CITY OF ALBUQUERQUE

Sites: La Cuentista III Rosa Parks/Kimmick – D10E002D

Re: Drainage Ordinance (14-5-2-11) Violations for Erosion and Sediment Control

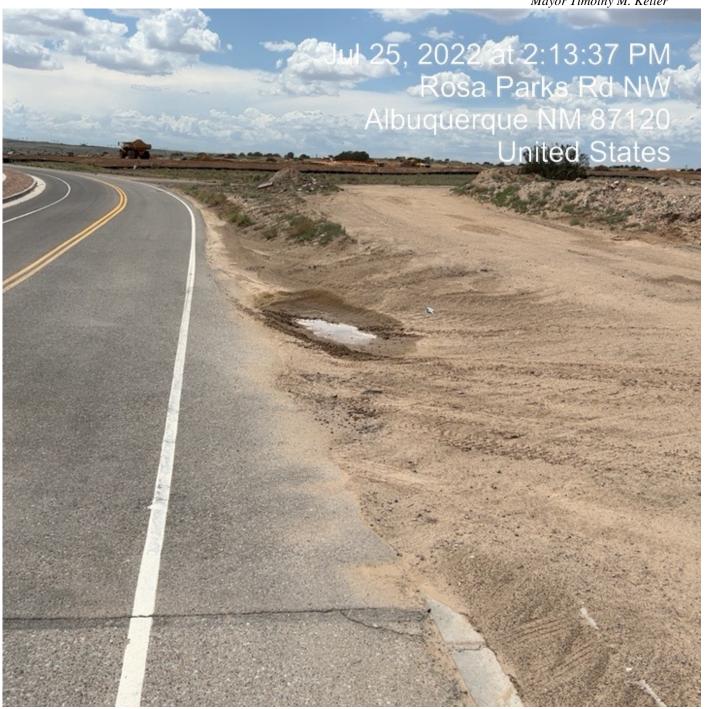
2. A SWPPP wasn't available onsite for the area of Construction Support Activities. Pulte's SWPPP didn't include the required information on the staging area (NOIs & SWPPP Map of BMPs) either.

3. BMPs were missing at the staging/stockpile area

- 2. An updated SWPPP Map of the staging/stockpile area with appropriate BMPs and stabilization must be submitted and approved by the City and then added to either Pulte's SWPPP or a new SWPPP for the stockpile area.
